Project	IEEE 802.16 Broadband Wireless Access Working Group http://ieee802.org/16 >			
Title	Modifications to UL map in OFDM mode and related issues			
Date Submitted	2003-11-13			
Source(s)	Shawn Taylor Wi-LAN	Voice:	+972-54-225549	
	Tal Kaitz, Naftali Chayat, Vladimir Yanover Alvarion	Fax: mailto: Naftali.Ch	Fax: +972-3-6456290 mailto: Naftali.Chayat@alvarion.com	
	John Dring, Intel			
Re:	IEEE 802.16-REVd Ballot			
Abstract				
Purpose	Material for resolution of comment XXX in LB13			
Notice	This document has been prepared to assist IEEE 802.16. It is offered as a basis for discussion and is not binding on the contributing individual(s) or organization(s). The material in this document is subject to change in form and content after further study. The contributor(s) reserve(s) the right to add, amend or withdraw material contained herein.			
Release	The contributor grants a free, irrevocable license to the IEEE to incorporate material contained in this contribution, and any modifications thereof, in the creation of an IEEE Standards publication; to copyright in the IEEE's name any IEEE Standards publication even though it may include portions of this contribution; and at the IEEE

Subcarrier allocation table

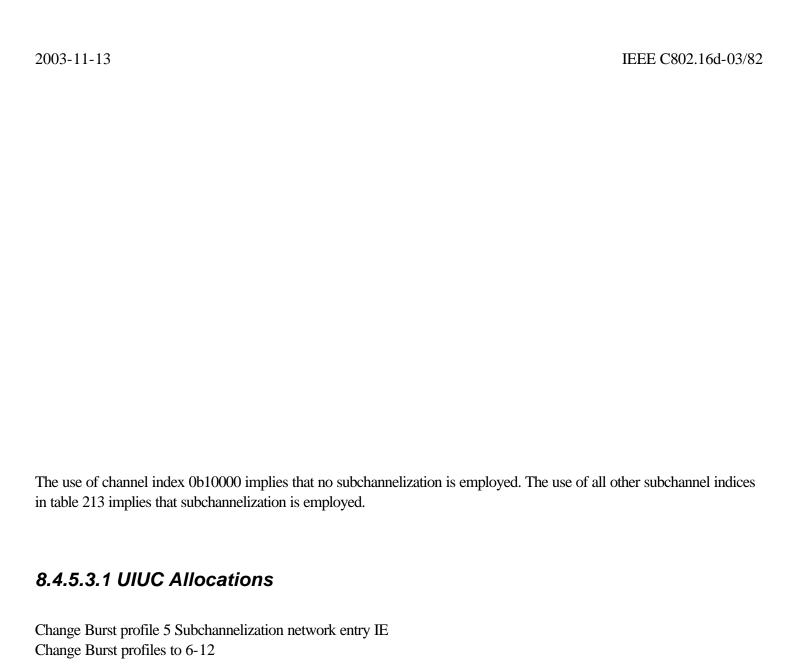
Modify as illustrated in the figure below:
